Knit Concept Ltd

North Norshingpur, Kashipur, Fatullah, Narayanganj

9 March 2025

1. Building Information

Observation 1: Stress in the foundation exceeds the normal design limit (Factory Building).

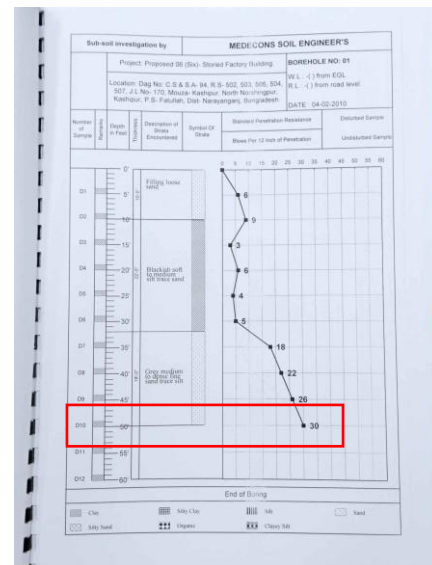
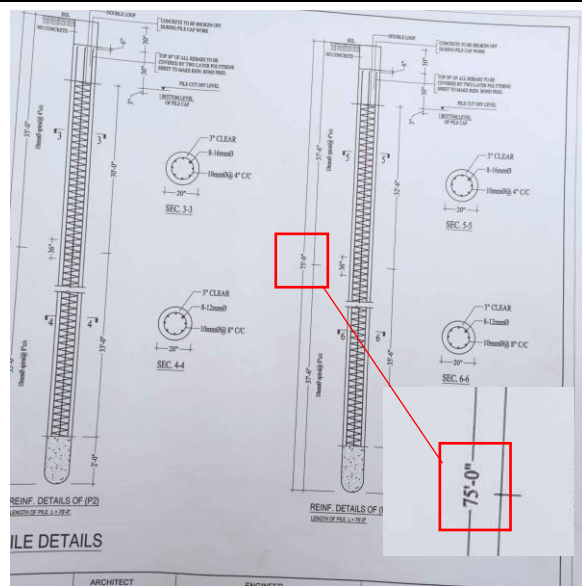
Description: cursory calculation indicates that stress in the foundation exceeds the normal design limit at marked locations considering the live load 3 kPa and allowable pile capacity 37.5-ton (FoS:2.5) at 14.63 m (48 feet) depth recommended in soil test report. Although as per the provided drawing, the pile depth is 22.86 m (75 feet), borehole data is available only up to 15.28 m (50 feet). A geotechnical engineer is required to prepare a new soil test report to determine the actual pile capacity up to the full depth of the pile. Based on the actual pile capacity, the building engineer is required to check the adequacy of the foundation and prepare a design report as per 1.9.1 BNBC. Submit it to RSC for review.

Item No.	Observation	Action Plan	Timeline
1.	Stress in the foundation exceeds the normal design limit (Factory Building).	A geotechnical engineer is required to prepare a new soil test report to determine the actual pile capacity up to the full depth of the pile.	within 6 weeks

2.		Based on the actual pile capacity, the building engineer is required to check the adequacy of the foundation and prepare a design report as per 1.9.1 BNBC. Submit it to RSC for review.	within 6 weeks

Observation 3: Stress in flat slab exceeds the normal design limit (Factory Building).

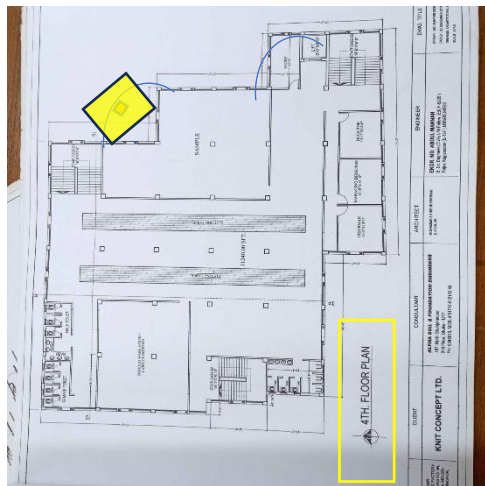
Description: Cursory calculation indicates that stress in flat slab exceeds the normal design limit at marked locations on the 4th floor due to brick partition walls and floor build-up, considering the live load of 2 kPa and minimum concrete strength (16.3 MPa) based on aggregate type. The building engineer is required to check the adequacy of the flat slab as part of the design report.

7.	Stress in flat slabs exceeds the normal design limit (Factory Building).	The building engineer is required to check the adequacy of the flat slab as part of the design report.	within 6 weeks

Observation 4: Discrepancy in construction/local authority approval drawing (Factory Building).

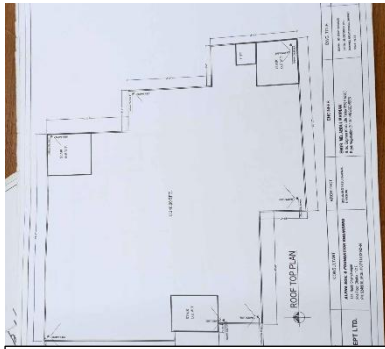
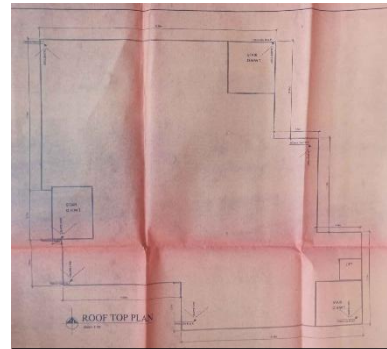
Undocumented extension at roof

Shape of the building doesn't match with drawing

Description: The additional floor on the roof was not shown both in the as-built drawing and layout from the local authority approval drawing. Also, the shape of the building on the east side is slightly different from both the as-built drawing and the layout from the local authority's approval drawing. The building engineer is required to produce an accurate as-built drawing as per on-site conditions. Also, collect a revised permit drawing/layout from the local authority for the additional floor at the roof and reflect the onsite condition. Otherwise, remove the undocumented floor at the roof.

8.		Take a minimum of 2 no of concrete core from the slab to verify the in-situ concrete strength.	within 6 weeks
9.	Discrepancy in construction/local authority approval drawing (Factory Building).	The factory is required to collect a revised permit drawing/layout from the local authority for the additional floor at the roof and reflect the onsite condition. Otherwise, remove the undocumented floor from the roof.	within 6 months

10.		Also, prepare an accurate as-built drawing as per the onsite condition.	within 6 weeks
11.	Lack of lateral stability (Utility Shed).	The building engineer is required to check the lateral stability of the shed and prepare an Engineering Assessment (EA) report as per 1.9.1 BNBC.	within 6 weeks

Observation-7: Nonstructural elements found not anchored/braced (Yarn Store Shed).

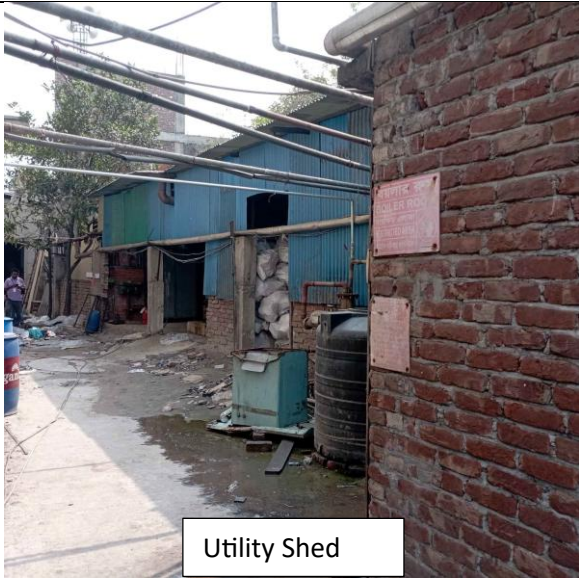
Description: Nonstructural elements (storage racks) were found not anchored/braced. The building engineer is required to anchor/brace all nonstructural elements within the factory.

13.	Absence of bracing system (Yarn Store Shed).	The building engineer is required to prepare a safety check report with a remediation plan incorporating a bracing system.	within 6 weeks
14.		Implement remediation work where required.	within 6 months
15.	Nonstructural elements found not anchored/braced (Yarn Store Shed).	The building engineer is required to anchor/brace all nonstructural elements within the factory.	within 6 months
16.	Lack of approval layout/drawing from local authority. (Yarn Store Shed, Utility Shed).	The factory is required to collect approval layout/drawing from the relevant local authority for all structures within the factory.	within 6 months
